Access Compliance Report

Public Rights-of-Way

(Curb Ramps)

Intersection ID: 45775	Main Street: BITTER_CREEK_DR	Cross Street: CARVER_FALLS_RD	Location: E
ADA ID: 4D19D8DEB027	Ramp Type: PerpDiag	Initial Pass/Fail: Fail	Overall Compliance: No
		Severity Score: 12.5

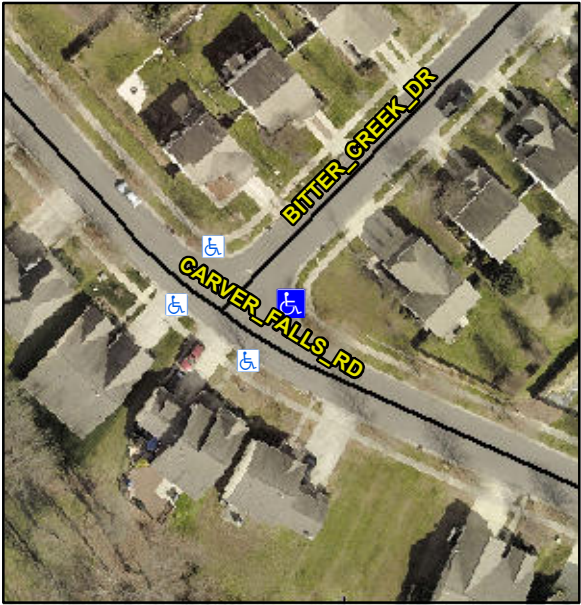
Codes/Mitigation Info/Possible Solution			Field Measurements/Component Compliance		
	Possible Solutions:		Compliance	Description	Data
	Remove & Replace Curb Ramp With Two New Directional Ramps or Equivalent.		Compliance	Description	Data
<p>Surveyor Notes:</p> <p>N/A</p>			N/A	Ramp Length (in)	60.0
			Yes	Ramp Width (in)	60.0
<p>PROW/ADA:</p> <p>R304.5.3</p>			N/A	Flare Type LT	N/A
			N/A	Flare Slope LT (%)	N/A
			N/A	Flare Traversable LT?	N/A
			N/A	Flare Slope RT (%)	N/A
			N/A	Flare Traversable RT?	N/A
			N/A	DWS Provided?	N/A
			N/A	DWS Contrast?	N/A
			N/A	DWS Length (in)	N/A
			N/A	DWS Full Width?	N/A
			N/A	DWS Offset (in)	N/A
			N/A	Shared Landing?	N/A
			N/A	Gutter Ponding?	N/A
			N/A	Gutter Lip Ht (in)	N/A
			N/A	Painted X Walk1?	No
				X Walk 1 Direction	To NW
			N/A	X Walk 2 Direction	To SW
			N/A	X Walk 1 Width (in)	N/A
			N/A	X Walk 2 Width (in)	N/A
				X Walk 1 Slope (%)	5.4
				X Walk 2 Slope (%)	1.6

X Walk 1 X Slope (%)	2.1
				X Walk 2 X Slope (%)	6.5
			N/A	Ramp inside XWalk1?	N/A
			N/A	Ramp inside XWalk2?	N/A
				Road Slope (%)	5.3
			N/A	Clear Space?	N/A
				Road X Slope (%)	4.6
			N/A	Clear Space to XWalk (in)	N/A
			N/A	Any Obstructions?	N/A
			N/A	Storm Grate/Utility Hazard?	N/A
				Obstruction Type	
			N/A	Storm Grate/Utility Type	
					N/A
			Yes	Surface Condition? (G/P)	Good
